Lamb Lakes, M-2018-039, Adequacy Response 1 Of 2

**RE: Response to Adequacy Review Comments for North Weld County Water District,
Lamb Lakes, File No. M-2018-039**

Rule 6.4.3 – Exhibit C – Pre-mining and Mining Plan Map(s) of Affected Lands

- Revised Exhibit C-5, Pre-mining and Mining Plan Map
- Revised Exhibit C-6, Water Resources Map
- Revised Exhibit F-1, Reclamation Plan Map

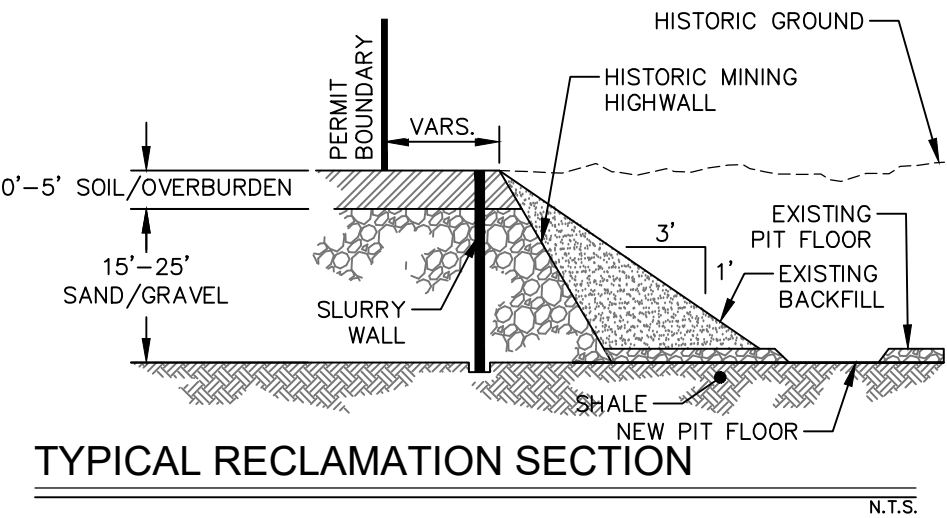
1. The topographic lines on Exhibits C-5, C-6, and F-1 have been corrected. Please see the revised exhibits in Attachment A.
2. The Fort Collins Irrigation Canal Ditch and Larimer and Weld Irrigation Ditch have been labeled on Exhibit C-6. Please see the revised Exhibit C-6 in Attachment A.

Figure 3. Estimated Groundwater Drawdown from Edge of Dewatered Lakes

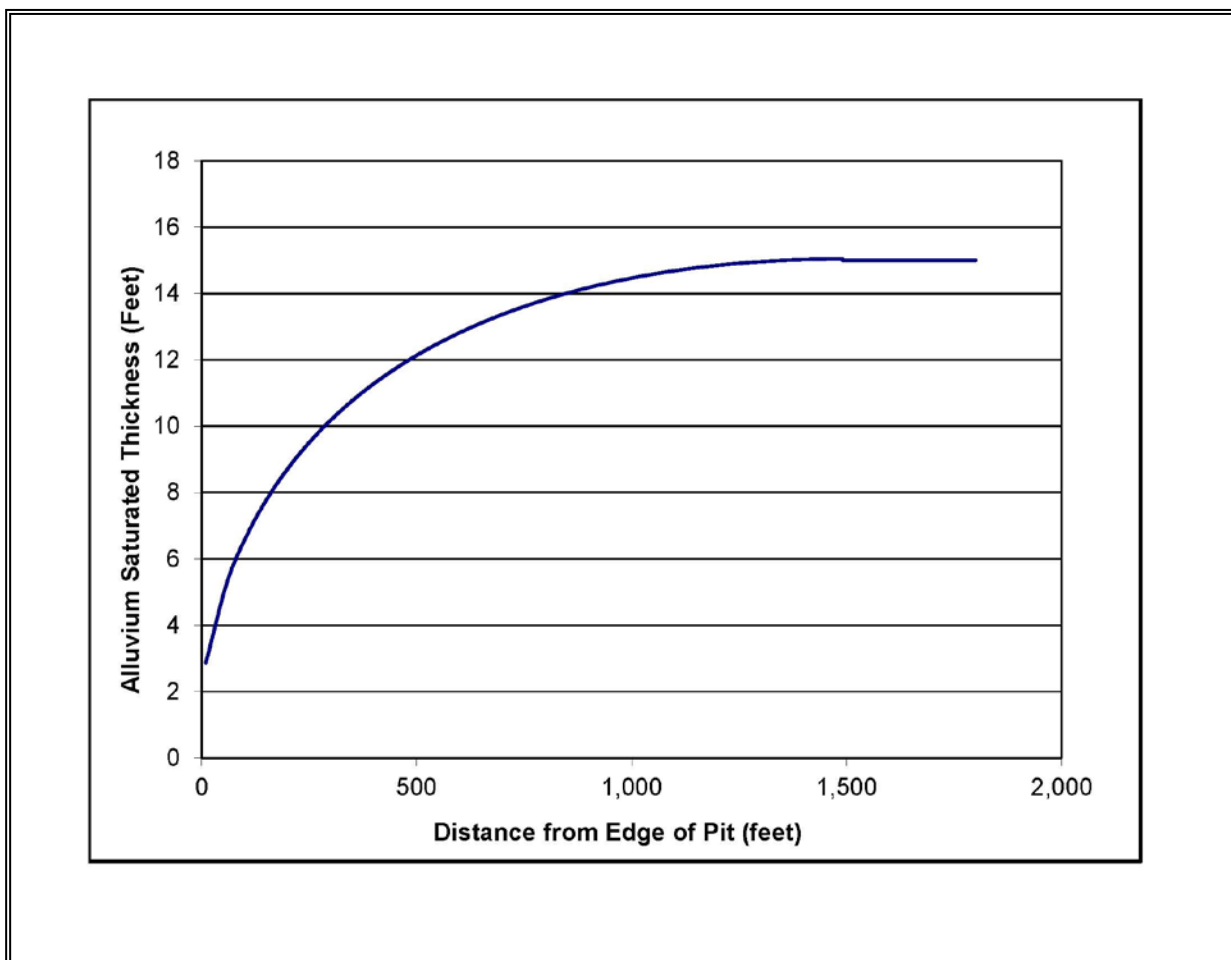
5. Site-specific groundwater information for the property is limited. Available site-specific and other alluvial information and evaluations are included in the attached Hydrogeologic Evaluation (see Attachment B). The evaluation provides an assessment of historic baseline groundwater conditions, potential impacts from lake dewatering and slurry wall construction, and recommendations for a groundwater monitoring plan.

As discussed above, the drawdown affects will be reduced by the Cache la Poudre River recharge and drawdown affects will not extend north or west of the river. The result of these affects on the radius of influence has been estimated in **Figure 4**. Although **Figure 4** presents an estimate of potential dewatering impacts, alluvial groundwater elevation monitoring is recommended to evaluate actual impacts.

Figure 4. Estimated Significant Groundwater Drawdown Boundary and Proposed Monitoring Well Locations

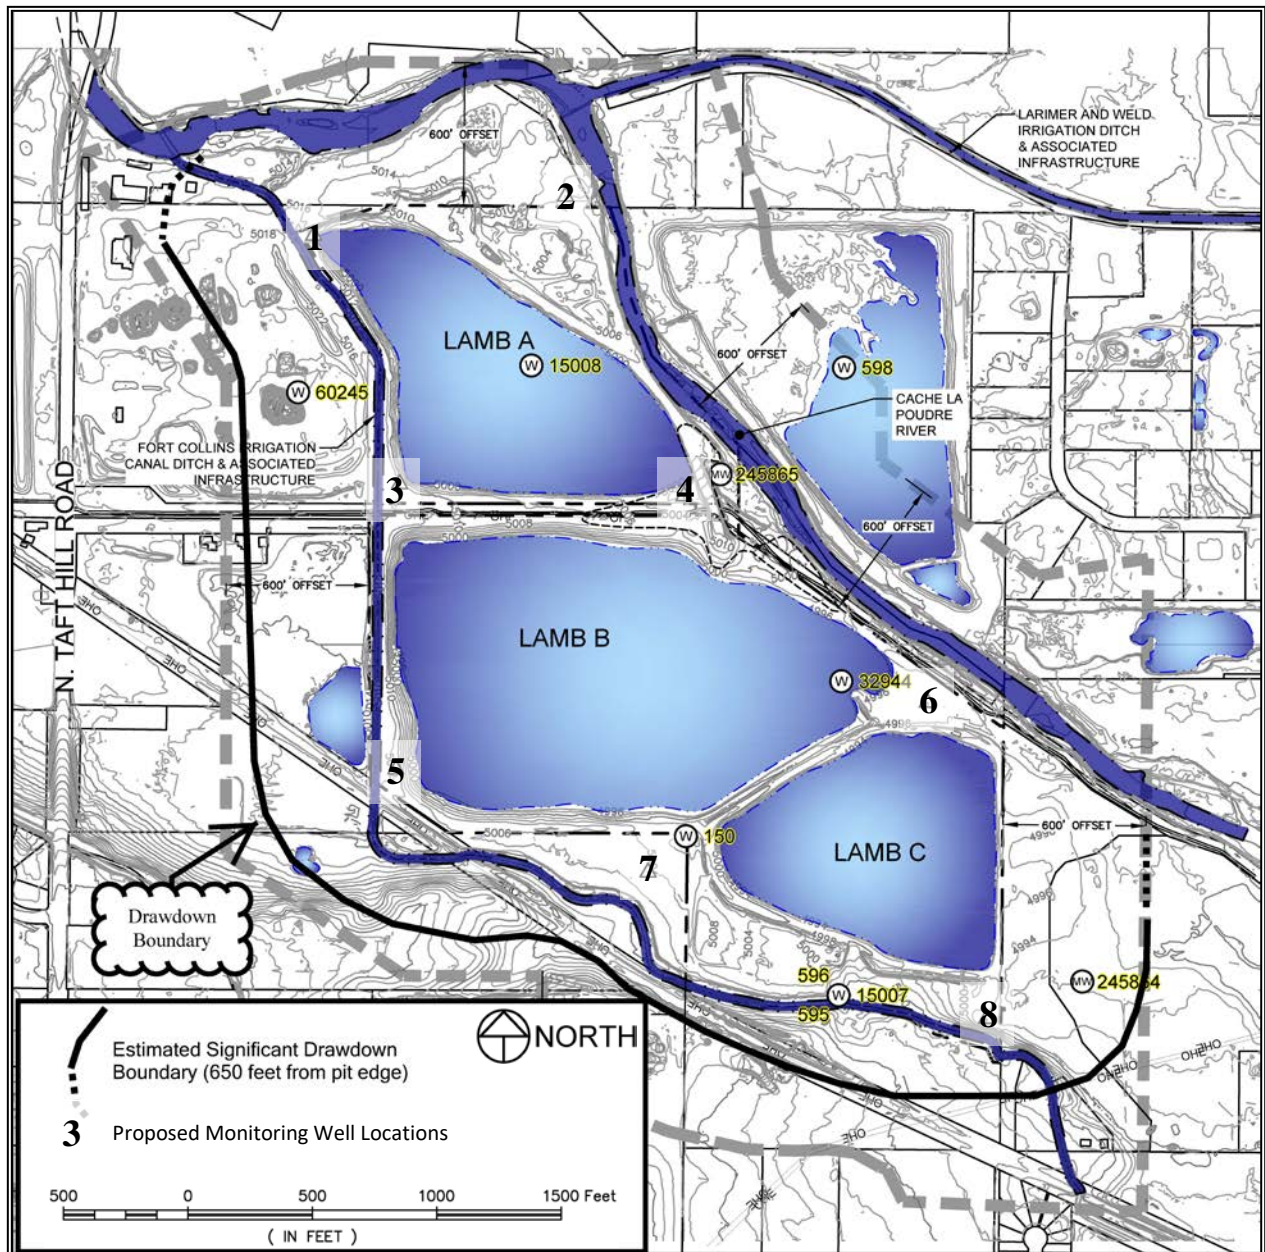
7. The Lamb Lakes Groundwater Monitoring Plan shall be established, incorporating the recommendations presented in the Hydrogeologic Evaluation (Attachment B). The recommendations include installation of eight monitoring wells, a minimum of 18 months baseline data collection prior to additional mining and reclamation activities, and a quarterly monitoring frequency. The monitoring plan shall be used prior to, during, and following mine operations and reclamation activities at the Lamb Lakes site and shall evaluate potential mining and reclamation impacts.

Approximate locations for alluvial wells to be included in the monitoring plan are illustrated on **Figure 4**. Locations identified in the figure are approximate, and actual monitoring well locations may vary depending upon the potential inclusion of existing wells and property use restrictions. If necessary, it is assumed that permission can be obtained from landowners to locate wells outside the permit boundary. Eight wells should be placed outside of the anticipated mining and reclamation activities, but within the estimated dewatering radius of influence. Dewatering and slurry wall impacts are not anticipated north and east of the Cache la Poudre River and, therefore, wells are not proposed across the river from the property.

Eight wells in the locations described are recommended for inclusion in the groundwater monitoring plan to evaluate general dewatering and slurry wall impacts. At the owner's discretion, extra wells may be added to the monitoring plan to evaluate groundwater impacts from specific mining, reclamation, or other aspects of property development. Additionally, wells may be added to the monitoring plan to specifically evaluate pre-existing or anticipated dewatering or slurry wall issues on adjacent properties.
